SERVICE BULLETIN

TITLE: TIME LIMITS - SCHEDULED-UNSCHEDULED MAINTENANCE
- Inspection of the mounting bushings of the horizontal stabilizer

Model:	AS365
Version:	N , N1 , N2 , N3 , F , Fs , K , K2

[SB AS365-05-00-0001](#)

Figure 1

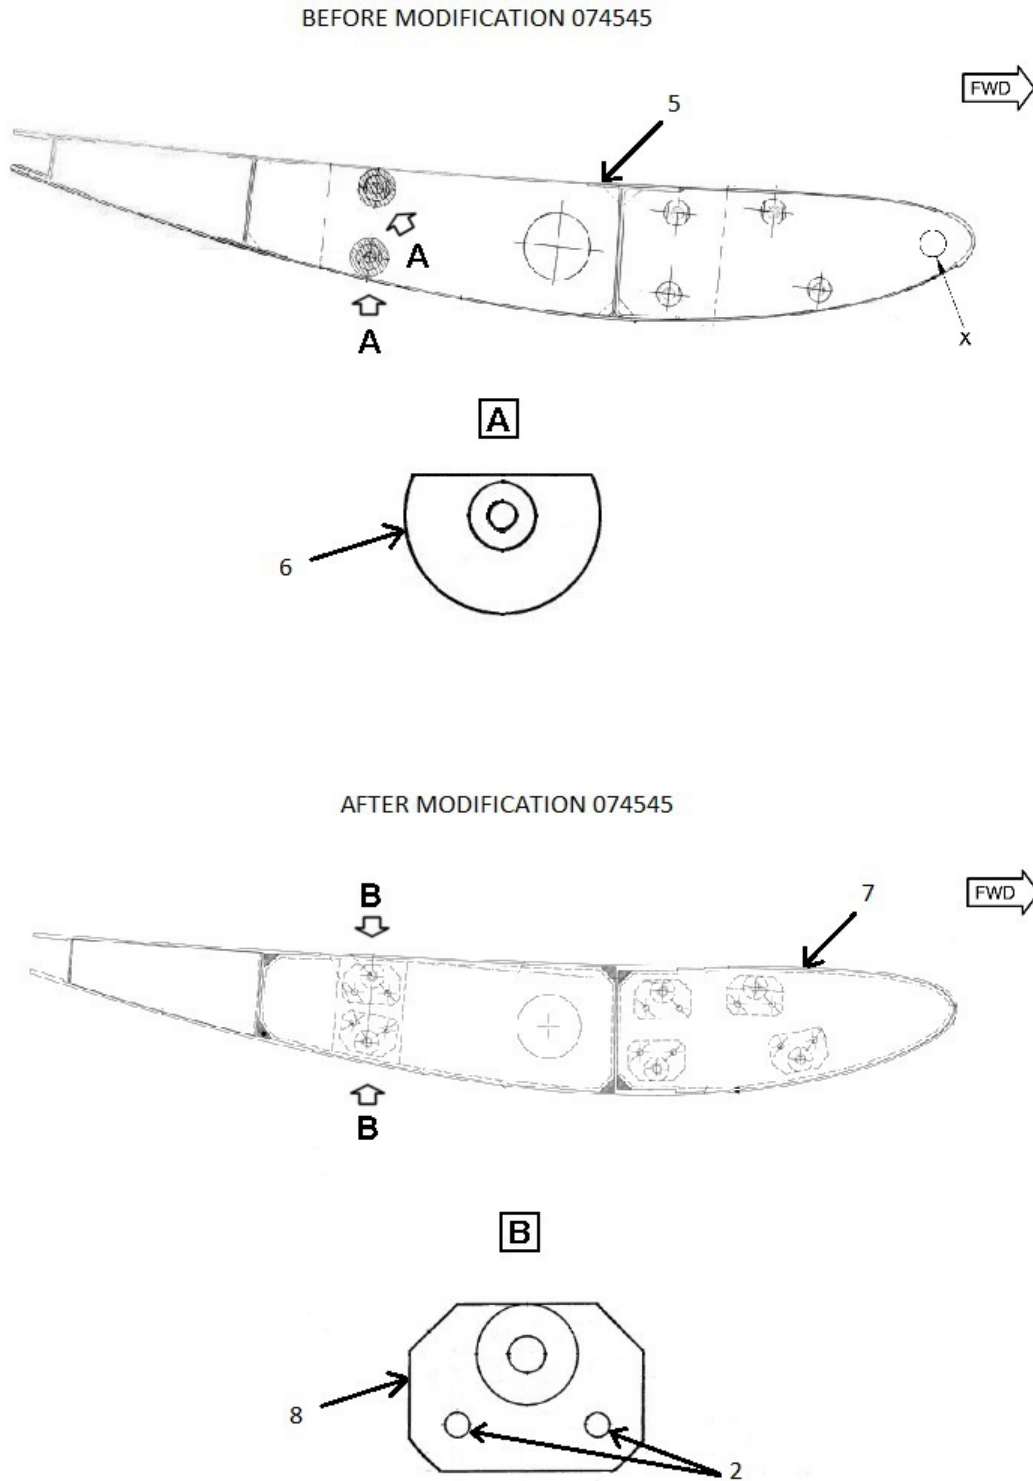
4.2.2. Do a visual check of the attachment of all the bushings (6) or (8) to identify the configuration of the horizontal stabilizer (PRE or POST MOD 074545) ([\(Figure 1\)](#)):

4.2.2.1. If the horizontal stabilizer (7) is equipped with a bushing (8) and two rivets (2), refer to Detail B, Figure 1:

4.2.2.2. If the horizontal stabilizer (5) is equipped with a bushing (6), refer to Detail A, Figure 1:

- Open and complete a Log Card (FM) with the S/N and the configuration. Refer to Work Card [MTC 20-08-05-101](#).
- Identify the S/N of the horizontal stabilizer (7), as given below:
 - The Serial Number of the horizontal stabilizer (7) is defined as follows: helicopter S/N, followed by the date of compliance (DDMMYYYY) with this Service Bulletin.
 - Example: helicopter S/N 6710, date April 01, 2024, the S/N of the horizontal stabilizer is 671001042024.
- Refer to the instructions of Work Card [MTC 20-08-05-103](#). In an Area Z of the horizontal stabilizer (7) that is free of markings, write with an indelible marker:
 - The S/N as defined above
 - The configuration: **POST MOD 074545** .

- Open and complete a Log Card (FM) with the S/N and the configuration. Refer to Work Card [MTC 20-08-05-101](#).
- Identify the S/N of the horizontal stabilizer (5), as given below:
 - The Serial Number of the horizontal stabilizer (5) is defined as follows: helicopter S/N, followed by the date of compliance (DDMMYYYY) with this Service Bulletin.
 - Example: helicopter S/N 5420, date June 12, 2024, the S/N of the horizontal stabilizer is 542012062024.
- Refer to the instructions of Work Card [MTC 20-08-05-103](#). In an Area Z of the horizontal stabilizer (5) that is free of markings, write with an indelible marker:
 - The S/N as defined above
 - The configuration: **PRE MOD 074545** .

Figure 2

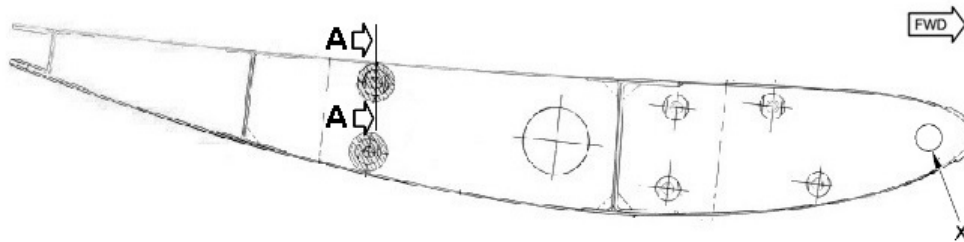
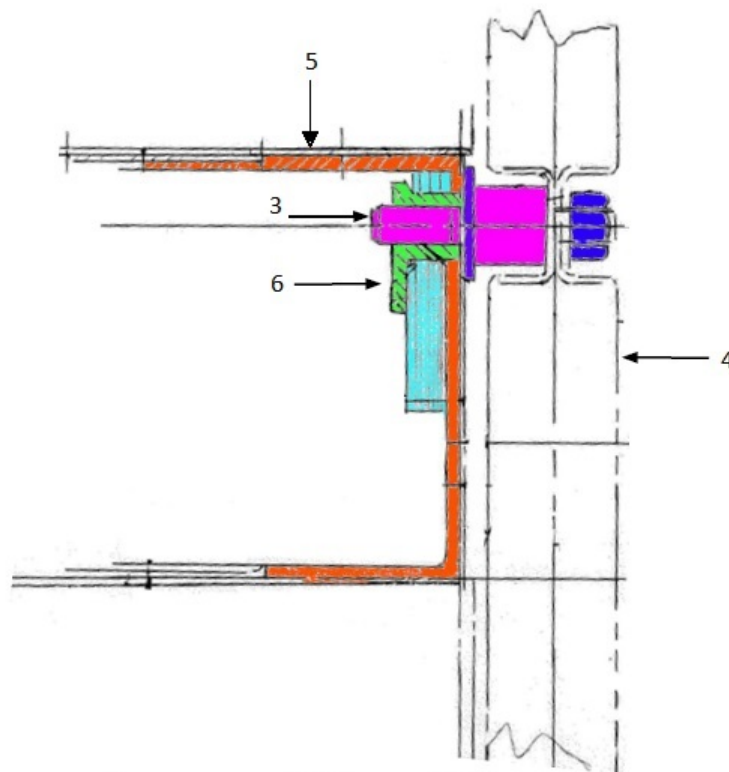
4.2.1. If necessary, remove the studs (3) (Section A-A, [\(Figure 2\)](#)).

- 4.3.1. If necessary, drill a 14 mm (.55 in) dia. hole (X) in the front part of the horizontal stabilizer outboard rib. Refer to the principle of Work Card [MRM 55-10-10-776](#).

- 4.3.2. Do an endoscopic inspection with the Borescope assembly (1) (not shown) on the inner surface of all the bushings (6) (Figure 2) to make sure that there is no corrosion or crack. Refer to [MTC 20-90-03-103](#).

- 4.3.3. Interpret the result:
 - 4.3.3.1. If there is no corrosion and no crack:
 - If removed before, install the studs (3).
 - If necessary, seal the hole (X). Refer to the principle of Work Card [MRM 55-10-10-776](#).

- Comply with paragraph 5. CLOSE UP.
 - 4.3.3.2. If there is corrosion and/or a crack at least one bushing (6):
 - Replace all the bushings (6). Refer to Work Card [MRM 55-10-10-777](#).
